# RENOVATION OF GALEHOUSE (A BUILDING), MCLEOD (S BUILDING), AND NATURAL SCIENCES (N BUILDING)

Cape Fear Community College Wilmington, North Carolina SCO #17-18154-01A; NCCCS #2352 BMG Project No. 2018023.00

#### **ADDENDUM NO. 1**

1 - Building "A" Roof Power, Lighting and Systems Plan Scale: 1/8" = 1'-0"

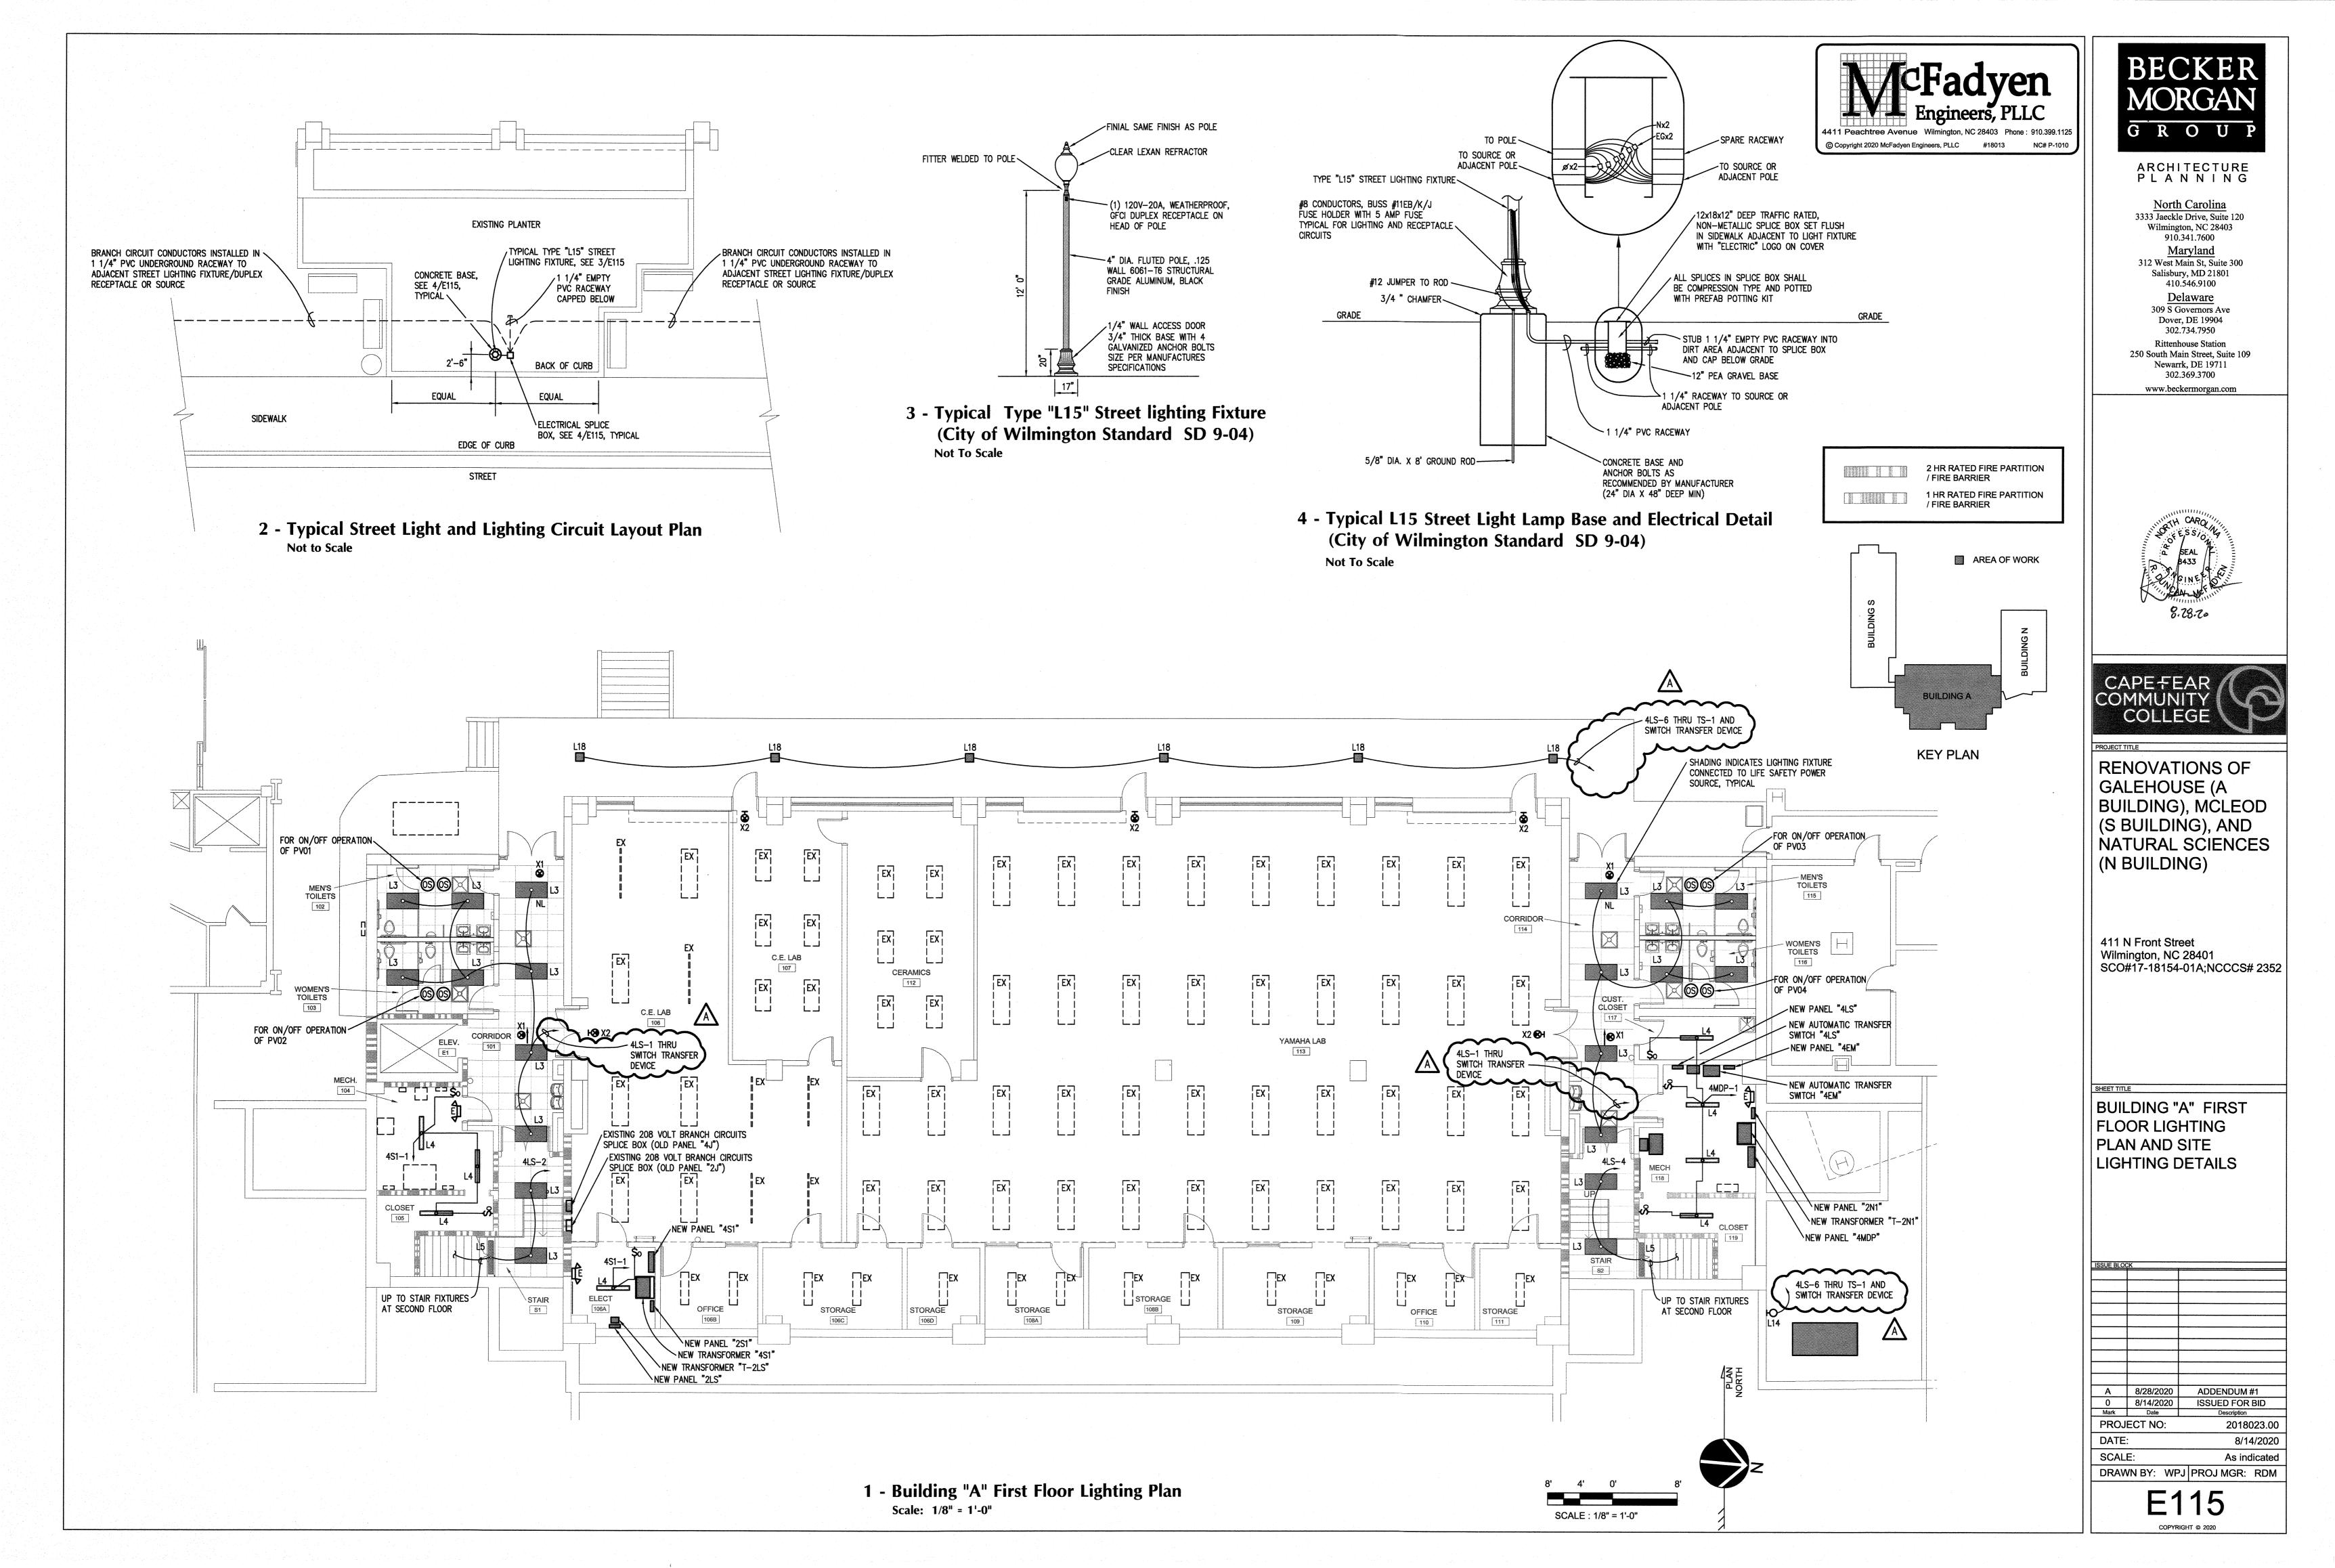
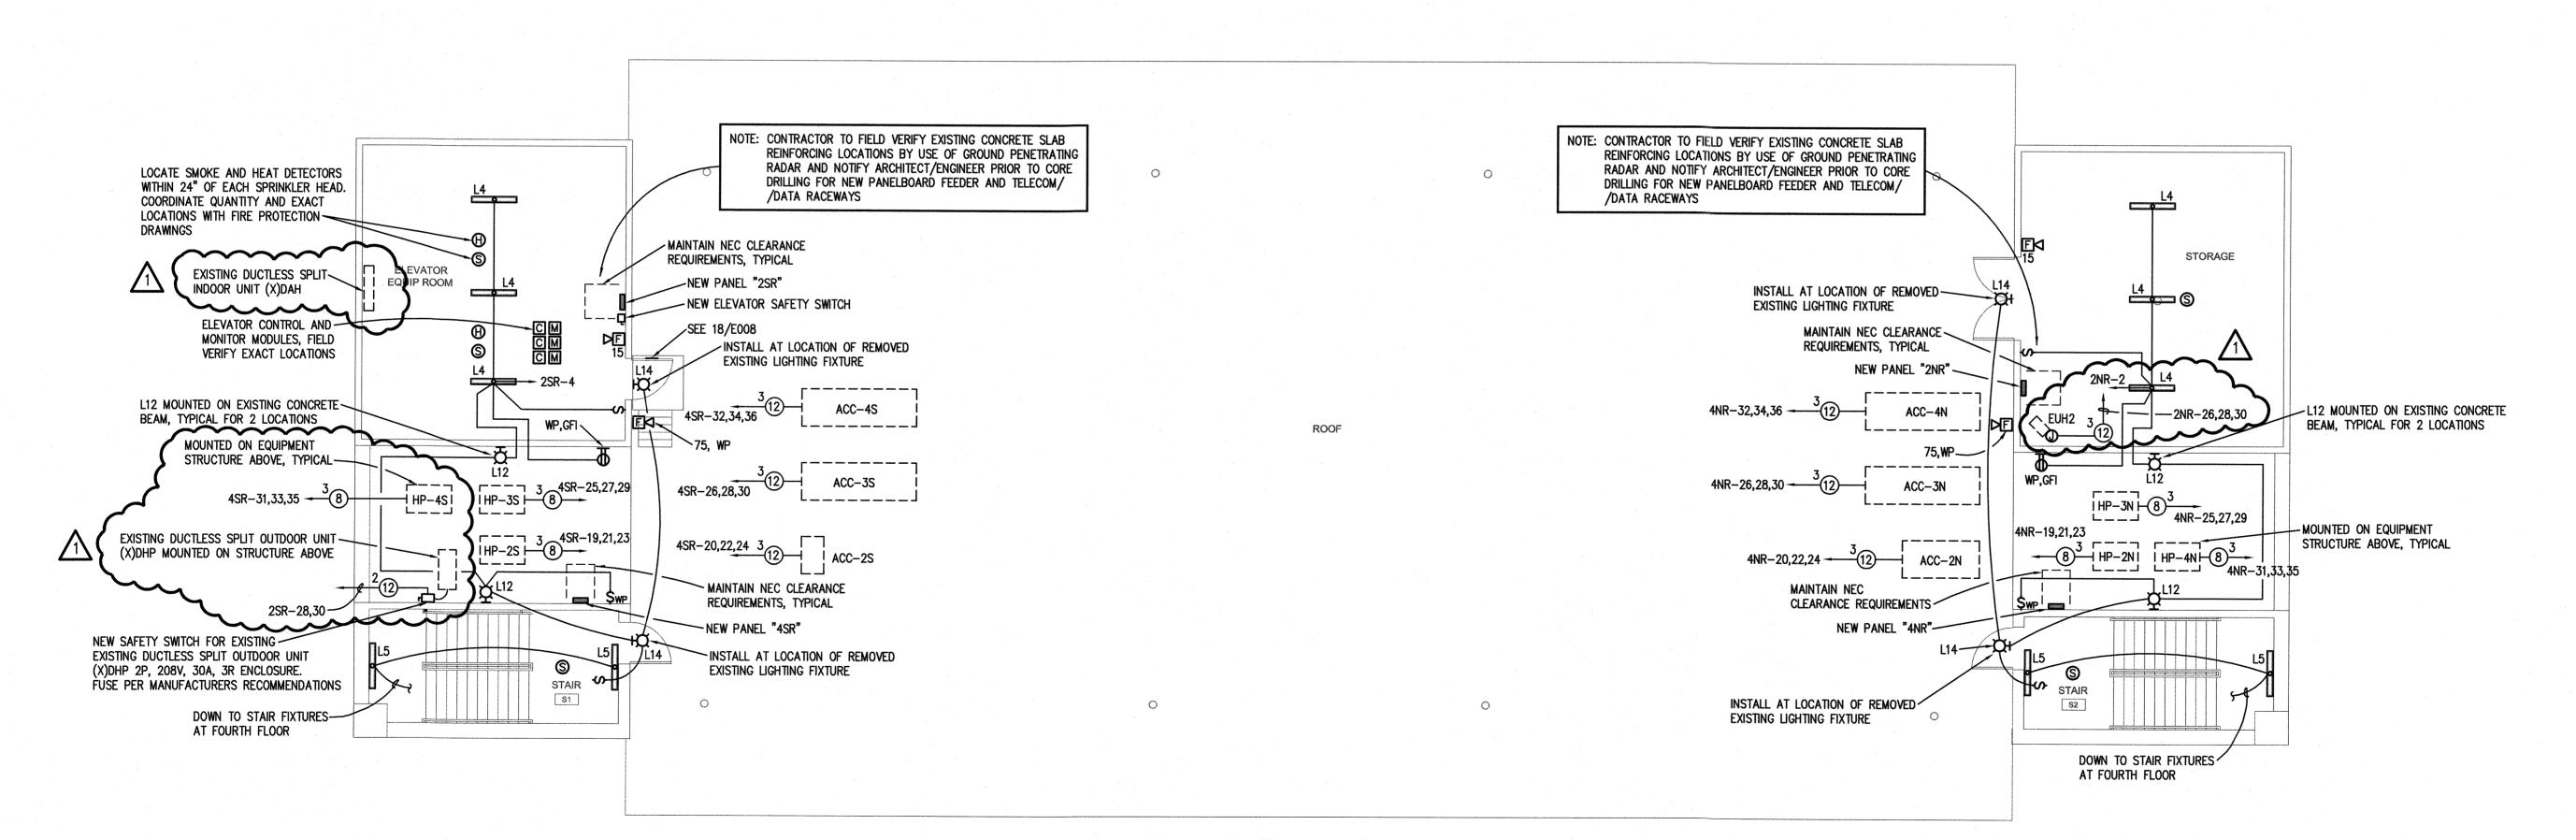
- r. E106A ALTERNATE 1 BUILDING "A" FIRST FLOOR POWER PLAN: REVISED new secondary service termination location in new Panel "4MDP".
- s. E110 BUILDING "A" ROOF POWER, LIGHTING AND SYSTEMS PLAN: REVISED. Added EUH2 location and branch circuit. Added existing ductless split unit location and branch circuit.
